**Notice of Allowability**

10/539,272

HANSCH ET AL.

### EXAMINER'S AMENDMENT

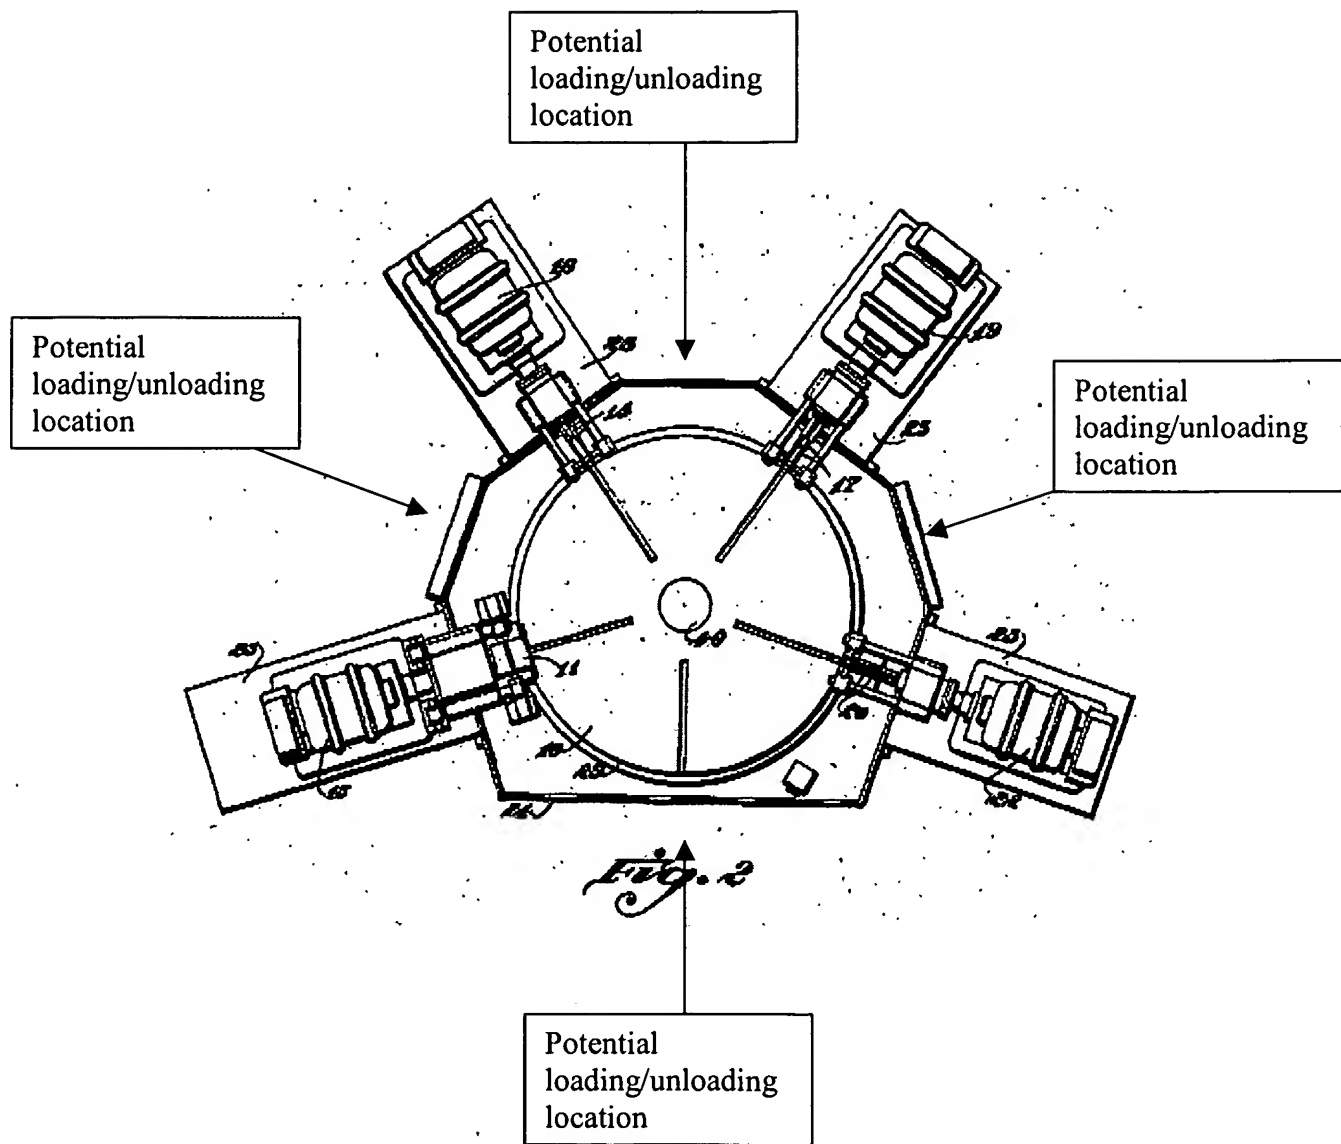
Also, regarding art exemplified by U.S. Pat. No. 2,271,848 to Tcimpidis ('848), '848 teaches a machine tool for the machining of workpieces including multiple machining modules (including the base portions 23 and the machine tools mounted thereon, see Figures 1-3) each having a spindle 13, 16, 19, 23, etc., having a horizontal spindle rotation axis (see Figures 1-3,

and page 2, left column, at least lines 12-42, for example). Note that the spindle rotation axes are non-parallel to one another as viewed in Figure 2, for example.

Additionally, '848 teaches a "clamping module" (including at least 24 and 10, see Figures 1-3, for example) having a horizontally oriented clamping surface (on the top of 10, see Figure 3, for example) for clamping workpieces (via work clamping fixtures 25, see page 2, left column, lines 12-18, for example) and that is rotatable around a vertical axis (see Figures 1-3, page 2, left column, lines 51-75, for example).

However, '848 teaches that the workpieces are loaded and unloaded from the worktable 10 of the clamping module manually by an operator (see page 2, left column, lines 43-51, for example) rather than by any "pallet changing module".

That being said, firstly, it is noted that the workpieces placed into the work clamping fixtures 25 of the clamping module do not appear to be palletized such that any "pallet changing module" would be used.

Even assuming *arguendo* that it would be obvious to modify the teachings of '848 such that palletized workpieces were used/exchanged, it is noted that '848 does not explicitly teach where the manual loading/unloading occurs. Below is a reproduction of Figure 2 with various possible manual workpiece loading/unloading locations labeled, noting that the workpiece can be removed at any point during the process, depending upon how many of the machining stations it is desired for it to pass through.

It is noted that even assuming arguendo that it would have been obvious to have provided some sort of “turntable pallet changing module” (which itself is debatable), it is noted that determining the precise location and placement of such a turntable pallet changing module such that the rotation axis thereof was “in an off-center position relative to each of the imaginary mid-planes which each extend parallel to the spindle axes” and such that the at least one pallet changing module is “coupled to said clamping module asymmetrically with respect to the mid-

planes” would involve improper hindsight reconstruction. Note that it is not inherent that the mere addition of a turntable pallet changing module would result in the rotation axis thereof being in an off-center position relative to each of the imaginary mid-planes or in such module being coupled to the clamping module asymmetrically with respect to the mid-planes (noting that several of the potential locations labeled above for a pallet changing module are aligned with a spindle axis, for example, and that some of these locations, such as the upper and lower ones, are not necessarily “asymmetric” with respect to the mid-planes of 16 and 19, or 13 and 22, for example).
